GLOBAL TOPICS REPORT ON THE PRESTANDARD AND COMMENTARY FOR THE SEISMIC REHABILITATION OF BUILDINGS

Prepared by
AMERICAN SOCIETY OF CIVIL ENGINEERS
Reston, Virginia

Prepared for
FEDERAL EMERGENCY MANAGEMENT AGENCY
Washington, D.C.

November 2000
Federal Emergency Management Agency
Washington, D.C.

Figure 5: General Component Behavior Curves

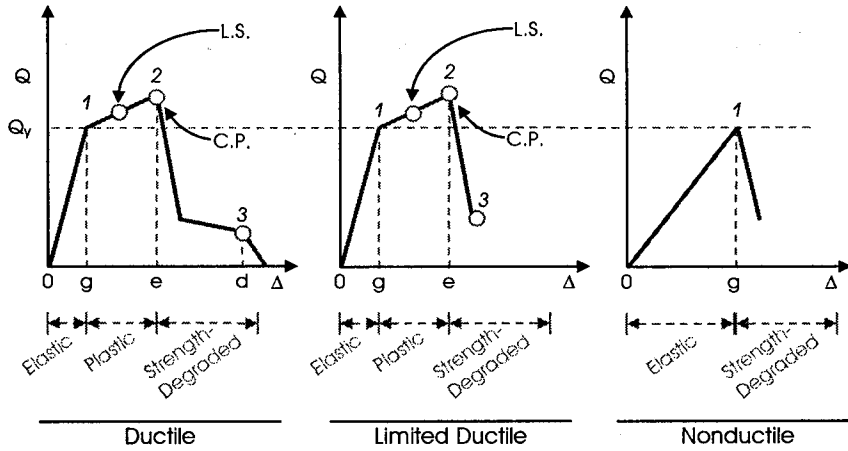
FEMA 273 acceptance criteria are set based on generalized component behavior curves corresponding to ductile, limited ductile or nonductile behavior. These curves, reproduced from FEMA 273, are shown in Figure 5. They are characterized by an elastic range, followed by a plastic range (with or without strain hardening), and finally a strength-degraded range. For ductile behavior the strength-degraded range includes significant residual strength. Nonductile behavior has no plastic range and little residual strength.

Using the curves in Figure 5, acceptance criteria for primary elements is set at point 2 for the Collapse Prevention Performance Level, and 75% of point 2 for the Life Safety Performance Level. As defined, the acceptance criteria limit the acceptable response of each component to the elastic or plastic regions of the idealized backbone curves. Primary lateral force resisting elements are not permitted to experience demands in the strength-degraded range. A building will fail the acceptance criteria as soon as the worst case primary element begins to degrade, which means that the overall structure is never permitted to experience degradation. This is not consistent with demands calculated presuming the presence of degradation and not consistent with the descriptions of damage used to distinguish between performance levels.

To establish an appropriate level of conservatism, this “double counting” should be eliminated. If demands are to be calculated presuming the components will degrade, the acceptance criteria should be consistently set permitting some level of degradation. The validity of this approach can be seen when considering the global behavior of a structure. Consider a four-story concrete shear wall structure with the pushover curve depicted in Figure 6. The curve was developed using components modeled with the full degrading backbone curves. Individual components were allowed to exceed collapse prevention acceptance criteria and slip into the degraded range of response. As can be seen by the curve, even as individual elements degrade, the overall structure maintains a stable level of resistance. The performance limit of the building is not reached until a significant number of components have had a chance to degrade.

Figure 6: Pushover Curve, Four Story Shear Wall (Building 9)

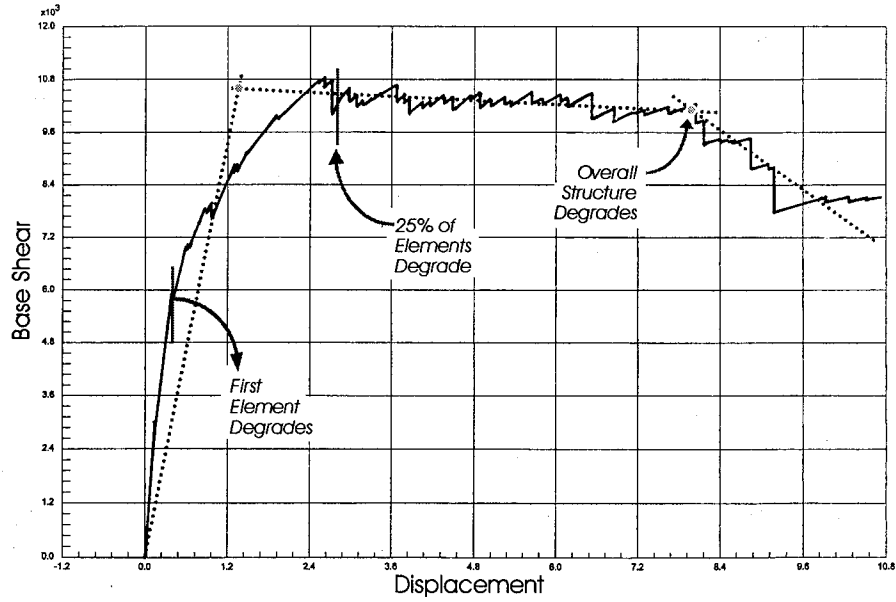
The proposed global acceptance criteria involves applying the concept of the idealized component backbone curve to the pushover curve of the entire structure. An example of this is shown in Figure 6. Global acceptance of the structure can be measured by selecting a performance point, such as the point where significant structural degradation occurs in Figure 6. Just as component acceptance criteria are set using the component backbone curve, the global performance levels can be set from the pushover curve as follows: CP – performance point; LS – 75% of the performance point; IO – 50% of the performance point. To draw the pushover curve, components are modeled using full backbone curves, including strength degradation and residual strengths, and are permitted to respond in the strength degraded range up to the current CP limits for secondary elements.

Figure 4-2 Elastic Solutions for Rigid Footing Spring Constants

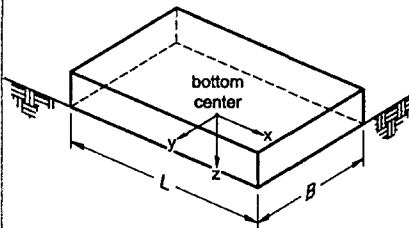
For use in this prestandard, the solutions for rectangular foundations with dimensions L and B are presented in Appendix B. It is recommended that this figure replace the current Figure 4-2. In general, a two step calculation process is required. First, the stiffness terms are calculated for a foundation at the surface. Then, an embedment correction factor is calculated for each stiffness term. The stiffness of the embedded foundation is the product of these two terms. [Appendix C also contains figures that illustrate the effects of foundation aspect ratio and embedment. Such figures were requested by members of the Project Team at the June 23, 1999 meeting.]

Resolution: Prestandard Figure 4-4 has been revised to include new equations for spring constants that are directly applicable to rectangular footings. Figure C4-1 is a graphical representation of information in the equations that has been added to the commentary for information only.

Figure 4-3 (a) Foundation Shape Effect (b) Foundation Embedment Effect

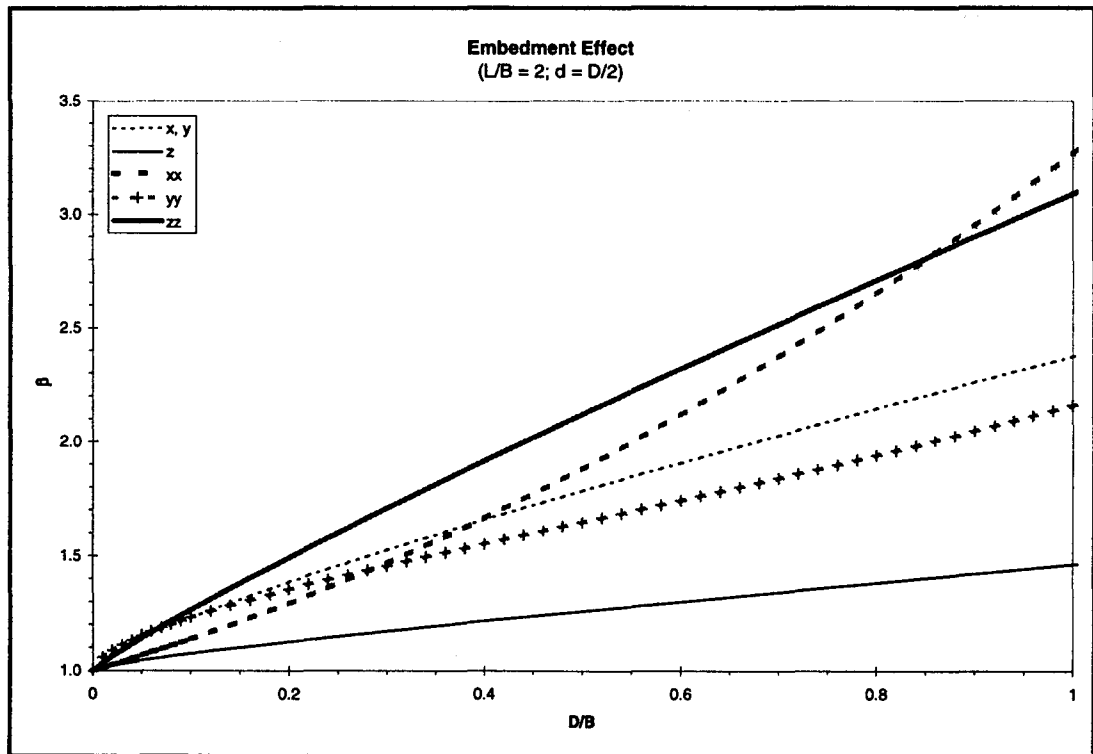
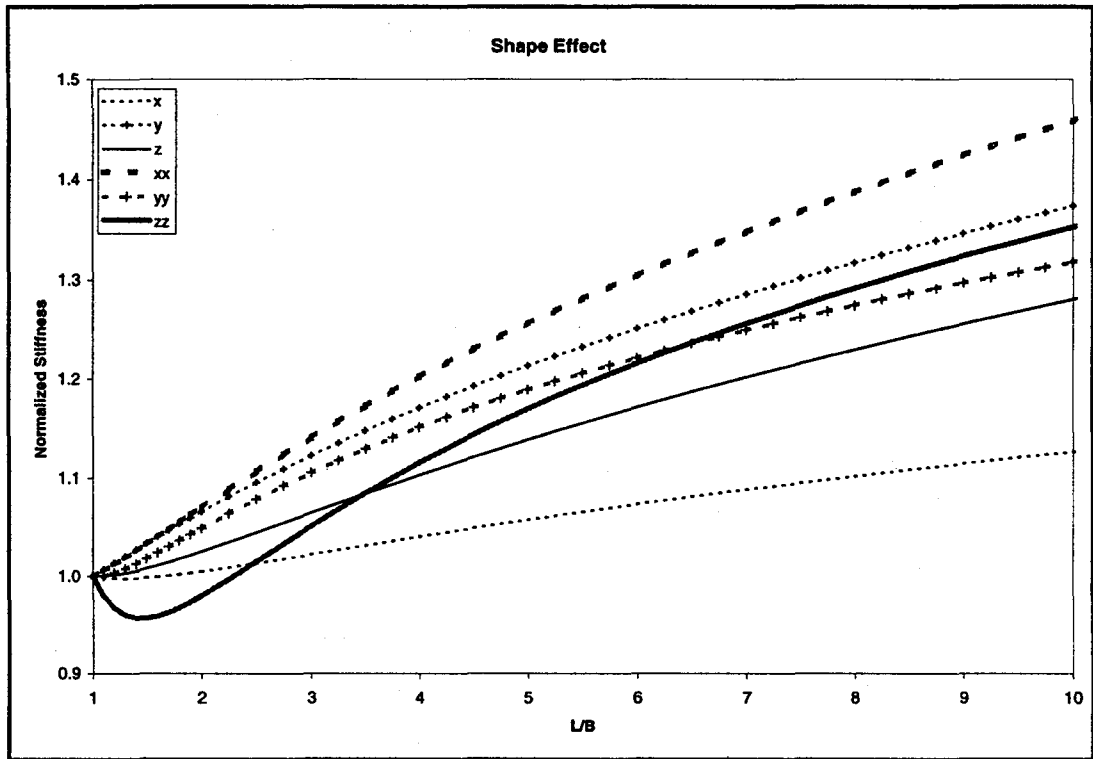
The original issue focuses on the applicability of the circular footing spring stiffness solutions to strip footings; the length to width aspect ratio in the current procedure (Figure 4-3a) is limited to a maximum of four. In the course of this project, it was also noted that the range of embedment reflected in the embedment correction factors (Figure 4-3b) is too small for most practical problems.

Figure 4-4 Passive Pressure Mobilization Curve

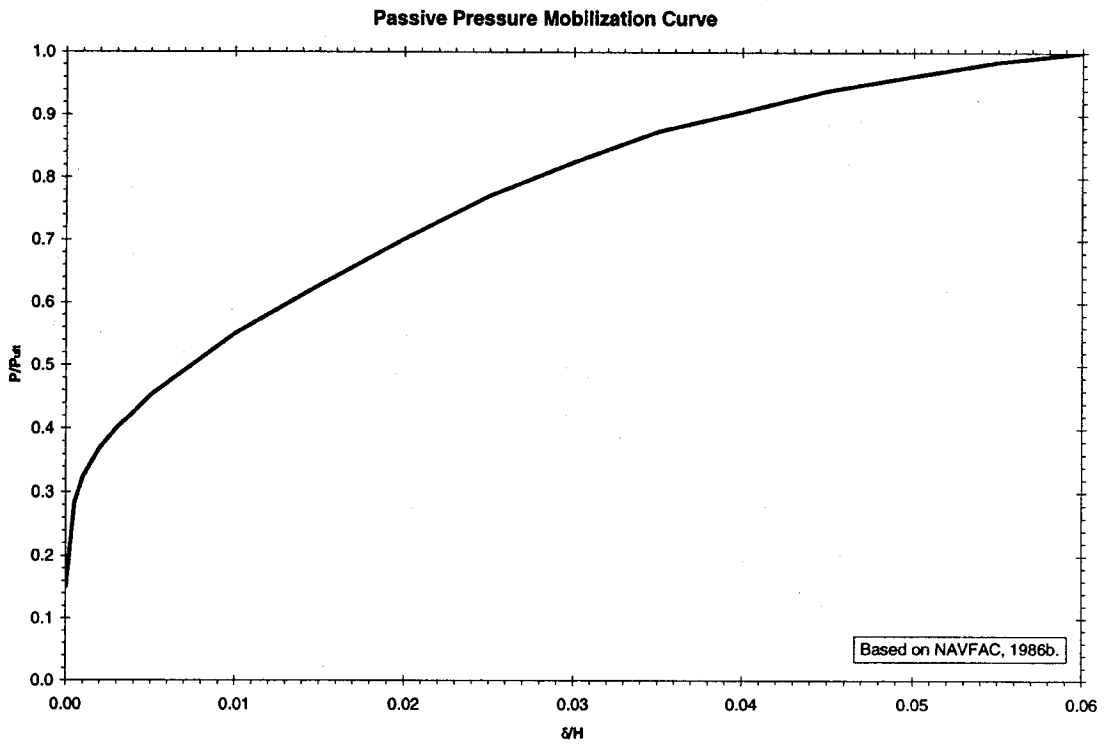
Discussion: Upon completion of the *Guidelines*, BSSC identified the need to conduct additional research on this issue. Special Study 4 – Foundation Issues was funded to research this issue further. The study concluded that the present linear relationship for passive pressure mobilization shown in *Guidelines* Figure 4-4 is unrealistic. The actual relationship is highly nonlinear.

Resolution: Prestandard Figure 4-6 has been revised to reflect the actual nonlinear relationship for mobilization of passive pressure.

Figure 4-x. Pile or Pier Capacities for Granular Soils (adapted from NAVFAC, 1986)

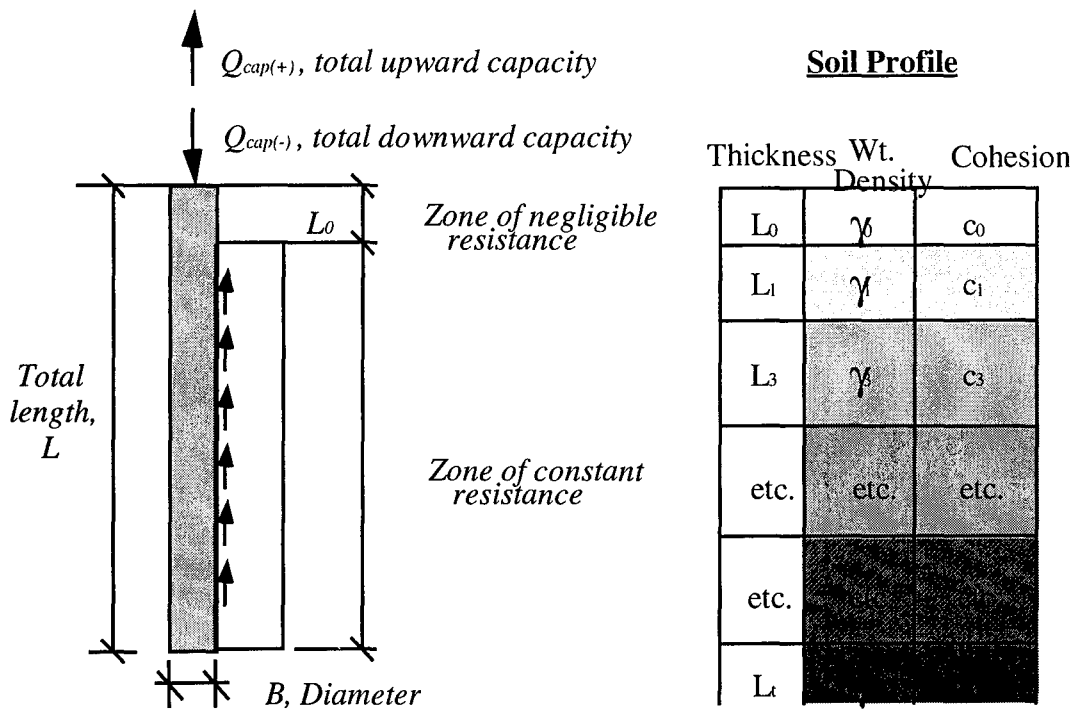
ATC11. Add presumptive capacities for piers and piles.

$$Q_{cap(+)} = \sum_{i=1}^{t-1} F_{ui} P_i \tan \delta_i a_s L_i$$

Where F_{ui} = Effective horiz. stress factor for upward load (see Table 4-y)
other parameters as for downward capacity

Figure 6-x: Identification of component types in wall elements (from FEMA 306(ATC, 1998a))

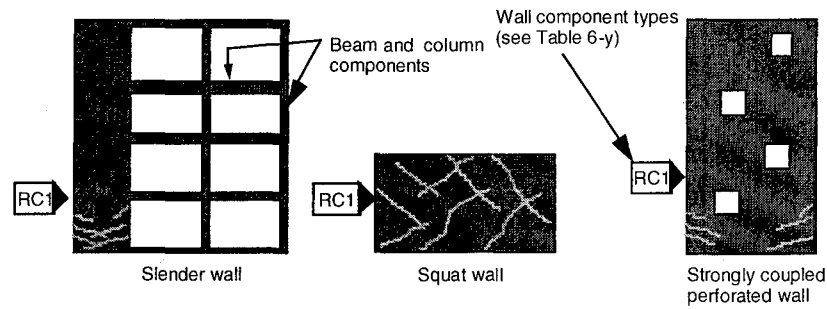
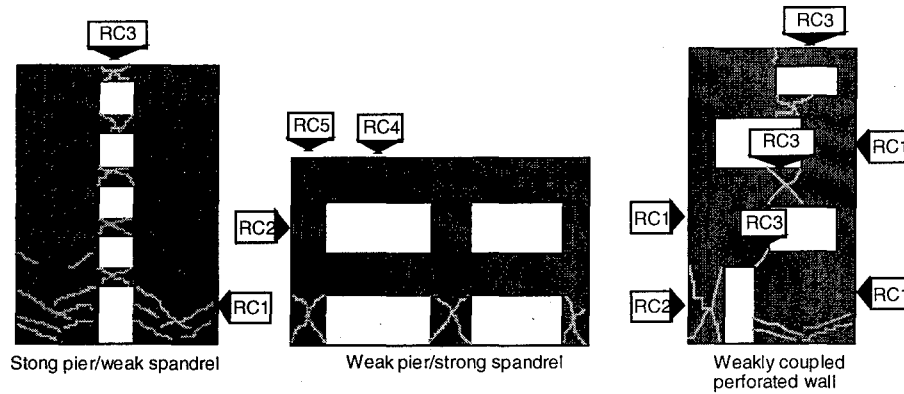
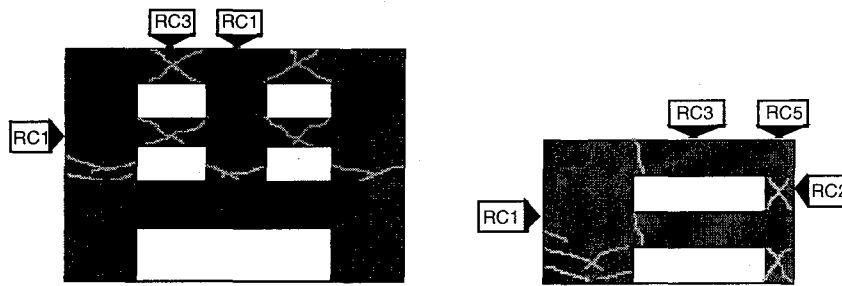
Suggested change: Add a paragraph C6.8.1.1.iii as follows:

“The identification of components in concrete shear wall elements depends on the relative strengths of the wall segments. Vertical segments are often termed piers, while horizontal deep beam segments are called coupling beams or spandrels. This concept is covered in FEMA 306 (ATC, 1998a) and ATC-40 (ATC, 1996). Typical components for concrete walls are summarized in Table 6-y from FEMA 306. A plastic analysis of the entire wall element as it is displaced laterally to form a mechanism can help to identify component types as shown in Figure 6-x.”

Figure 6-y: Component Modeling Criteria (from FEMA 306)

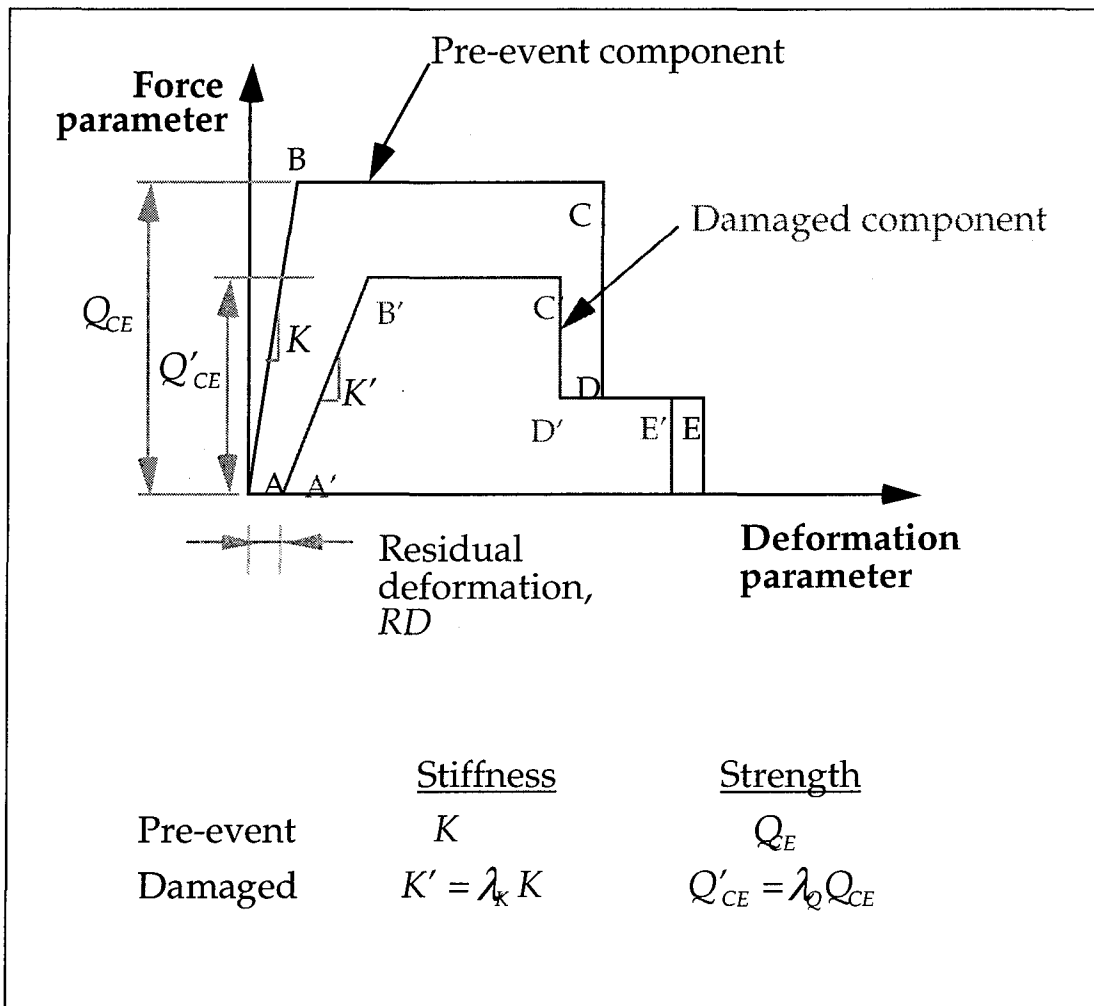
Add a paragraph C6.8.2.1.zz as follows:

“FEMA 306 and 307 (ATC, 1998a, b) contain extensive information on the properties and behavior of damaged concrete shear walls. Although developed for the purpose of evaluating earthquake damage, these documents can provide expanded information to address specific conditions encountered for individual buildings. The effects of damage on component behavior are modeled generically in Figure 6-y. Acceptability criteria for damaged components are illustrated in Figure 6-z. The factors used to modify component properties for observed damage range from 0.0 to 1.0 and are defined as follows:

Figure 6-z: Component Acceptability Criteria (from FEMA 306)”

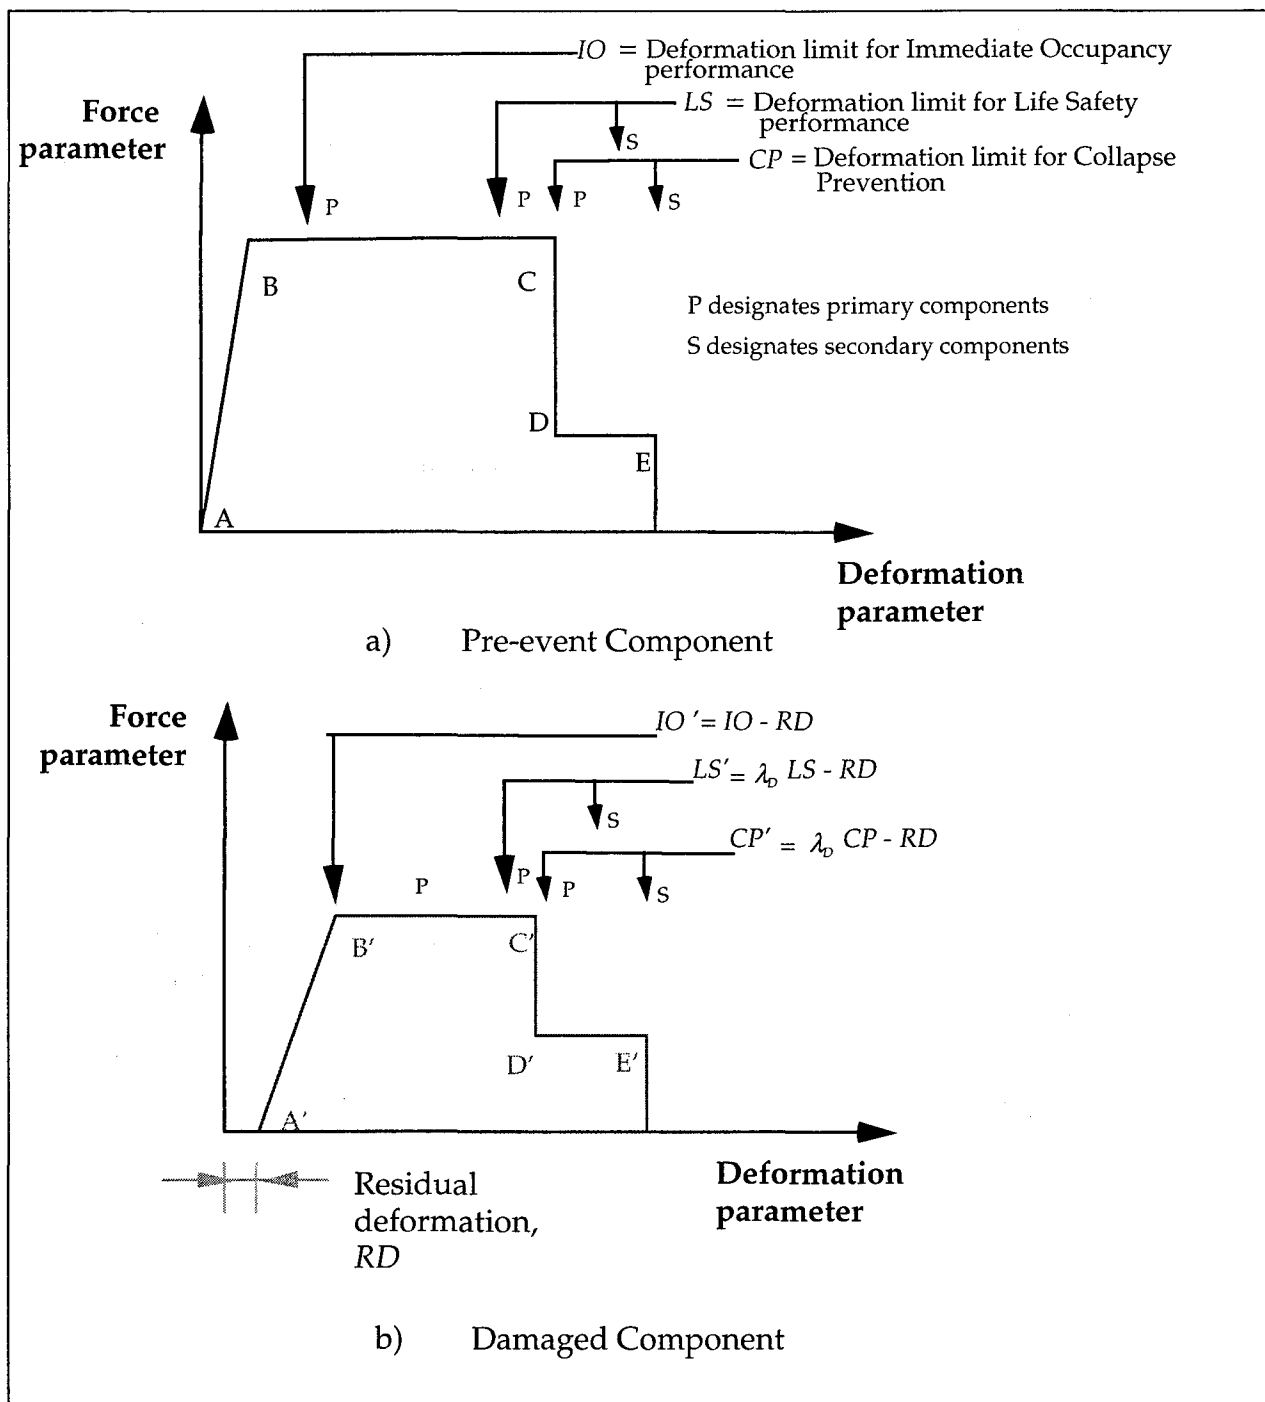
Discussion/justification: Since they are not consensus standards, FEMA 306 and 307 cannot be explicitly cited as alternative provisions, and their use must be subject to approval. Nonetheless, the data in the documents provide an opportunity to expand the scope of FEMA 273 to include damaged concrete shear walls.
